Informal document **GRSG-109-15**  
(109th GRSG, 29 Sept.-2 October 2015,  
agenda item 9)

## **GRSG 109th session**

**AEGPL presentation to  
ECE/TRANS/WP.29/GRSG/2015/35**

## LPG-system components – Compatibility with petrol

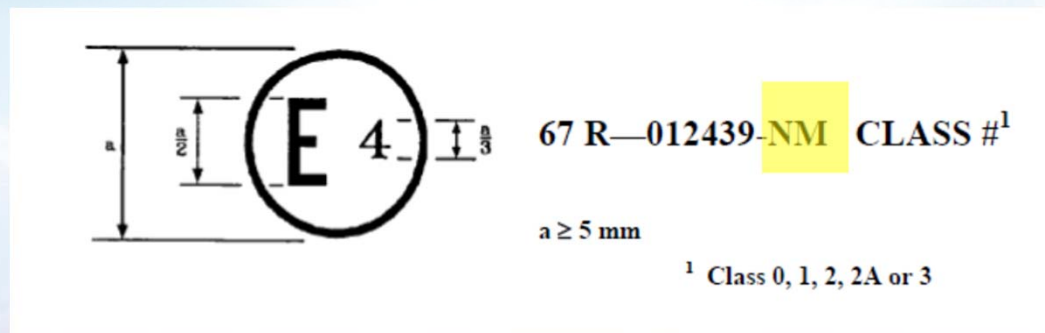
- Non-metallic, metallic or a mixture of metallic and non-metallic LPG components, including flexible hoses and their elements, and non-metallic, metallic or a mixture of metallic and non-metallic parts of LPG components which may come into contact with petrol shall be compatible with petrol (in addition to LPG).

- Non-metallic parts of components shall be subject to an immersion test (ISO 1817) in petrol (E10);
- Metallic components or parts shall be subject to a corrosion resistance test (R 67/01, Annex 15, par. 12)
